# UNITED STATES PATENT AND TRADEMARK OFFICE

APPLICATION NO.	FILING DATE	FIRST NAMED INVENTOR	ATTORNEY DOCKET NO.	CONFIRMATION NO.
10/733,568	12/12/2003	Satoshi Kojima	03500.017762.	8616
5514 7590 12/20/2006 FITZPATRICK CELLA HARPER & SCINTO 30 ROCKEFELLER PLAZA NEW YORK, NY 10112			EXAMINER DOTE, JANIS L	
			ART UNIT 1756	PAPER NUMBER
SHORTENED STATUTORY PERIOD OF RESPONSE		MAIL DATE	DELIVERY MODE	
2 MONTHS		12/20/2006	PAPER

<b>Office Action Summary</b>	Application No. 10/733,568	Applicant(s) KOJIMA ET AL.	
	Examiner Janis L. Dote	Art Unit 1756

## FIG. 2 PRIOR ART

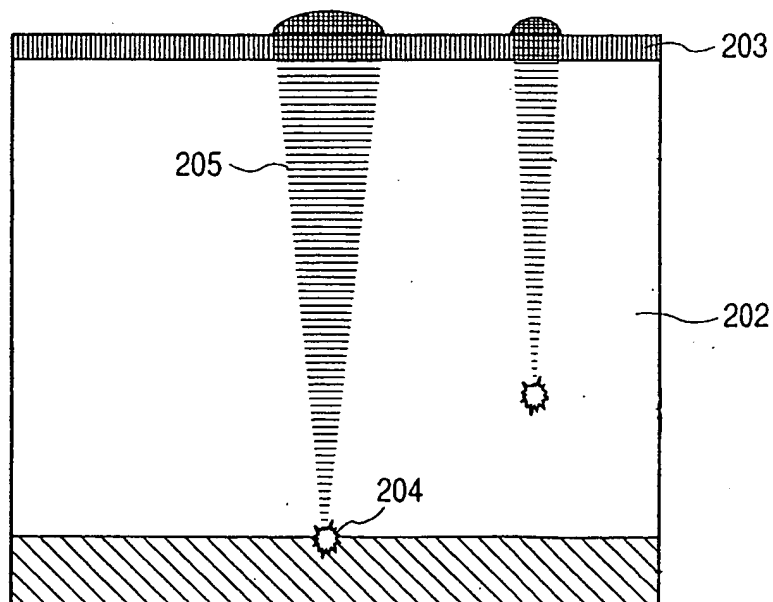
4. The replacement drawing sheets filed on Jul. 31, 2006, are not acceptable because they did not address all of the objections to Fig. 2 set forth in the office action mailed on May 15, 2006, paragraph 2. The replacement drawing sheet of

Fig. 2 includes the reference characters **204** and **205**, which are not mentioned in the description.

7. The drawings are objected to as failing to comply with 37 CFR 1.84(p)(5) because they include the following reference character(s) not mentioned in the description:

In Fig. 2, the reference characters **201**, **204**, and **205**. See the instant specification, page 4.

Figure 2 should be designated by a legend such as --Prior Art-- because only that which is old is illustrated. See the instant specification, page 4, lines 11-14, which identifies the drawing as "an example of protuberances in a conventional electrophotographic photosensitive member." See MPEP § 608.02(g).

DO NOT  
ENTER BOTH  
REPLACEMENT SHEETS  
NOT ACCEPTABLE  
D. D. D.  
12/14/06

Corrected drawing sheets in compliance with 37 CFR 1.121(d), or amendment to the specification to add the reference character(s) in the description in compliance with 37 CFR 1.121(b) are required in reply to the Office action to avoid abandonment of the application. Any amended replacement drawing sheet should include all of the figures appearing on the immediate prior version of the sheet, even if only one figure is being amended. Each drawing sheet submitted after the filing date of an application must be labeled in the top margin as either "Replacement Sheet" or "New Sheet" pursuant to 37 CFR 1.121(d). If the changes are not accepted by the examiner, the applicant will be notified and informed of any required corrective action in the next Office action. The objection to the drawings will not be held in abeyance.

Corrected drawings in compliance with 37 CFR 1.121(d) are required in reply to the Office action to avoid abandonment of the application. The replacement sheet(s) should be labeled "Replacement Sheet" in the page header (as per 37 CFR 1.84(c)) so as not to obstruct any portion of the drawing figures. If the changes are not accepted by the examiner, the applicant will be notified and informed of any required corrective action in the next Office action. The objection to the drawings will not be held in abeyance.
